Access Compliance Report

Public Rights-of-Way

(Island Curb Cuts)

| Intersection ID: 10029218 | Main Street: JOHNSON AND WALES_WY | Cross Street: N/A | Location: N |

| ADA ID: 1F0AD2B08013 | Curb Cut Type: MedianRefuge2 | Initial Pass/Fail: Fail | Overall Compliance: No |

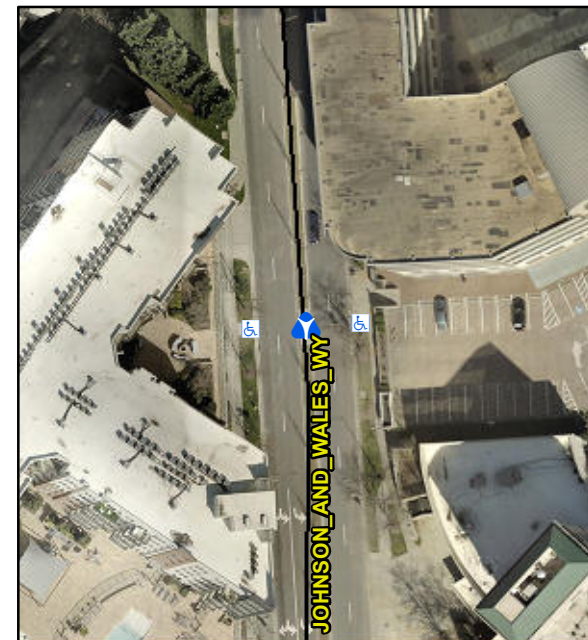
| Compliance | Description | Data | Compliance | Description | Data |
|------------|----------------------|------|------------|-----------------------------|------|
| No | Refuge 1 Length (In) | 30.0 | N/A | Gutter 1 Ponding? | N/A |
| No | Refuge 2 Length (In) | 30.0 | N/A | Gutter 2 Ponding? | N/A |
| No | Refuge 2 X Slope (%) | 6.0 | N/A | Gutter 2 X Slope (%) | N/A |

Remove & Replace Entire Refuge.
